RE: DA22/0417 – Response to RFI - Supporting information
Property: 158-164 Old Bathurst Road, Emu Plains

Reference is made to the above development application (**DA**) seeking consent for the proposed industrial subdivision of the land at 158-164 Old Bathurst Road, Emu Plains (the **Site**).

Figure 2 Available building envelope on Lot 9

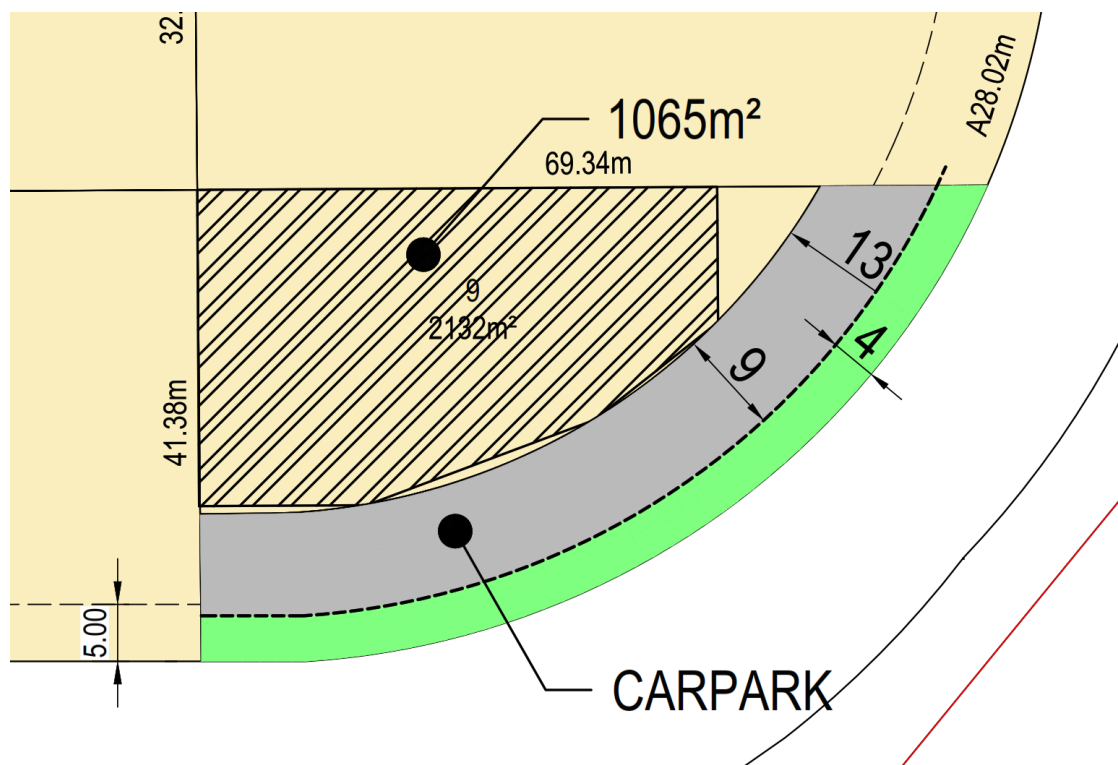
- **Lot 9** – as demonstrated in **Figure 2**, utilising the setback controls within the DCP, the Lot can accommodate a building footprint of approximately 1,100m², which is consistent with the building size being delivered in surrounding industrial locality.
